Re: 19 Cottage Screet

#### APPLICATION FOR PERMIT

Mr. Kyron Finkleman 19 Spruce Street Portland, Maine Subject: Application for permit to construct addition at second floor level on top of existing one story addition 5% x 25° and to change use from one family to two family dwelling house at 19 Cottage Street.

indicated Addition to Second Story 19 Cottage st. Fortland Me. Manning Comment

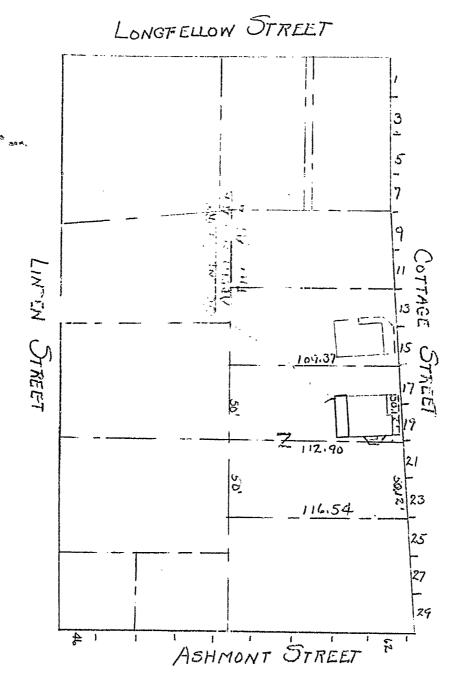
You are hereby advised that the bay window of the house at 19 Cottage st. is 5 inches ever the lot line.

The measurements for the front is 46 ft. and the rear is is 47 ft. 8 in. The bay window projects 2 feet 9 in. from the side of the house.

- 1. The permit is issued on the basis 'hat since the bay window on the side of the dwelling overhangs the respect to let line separating two fifty foot lets, this let line in thereby that and the two lets are one. In the future should development of the return pertian of the second let be planned, it will be necessary to set the located at least five feet from all parts of the bay window.

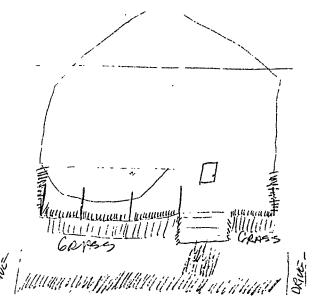
Your permit to demolish your borch and repair, as per plan, at 19 Cottage Street is being issued with the following requirement, that the sono tubes will rest on a footing with a pin anchoring both together, and extend at least 4 ft. below grade.
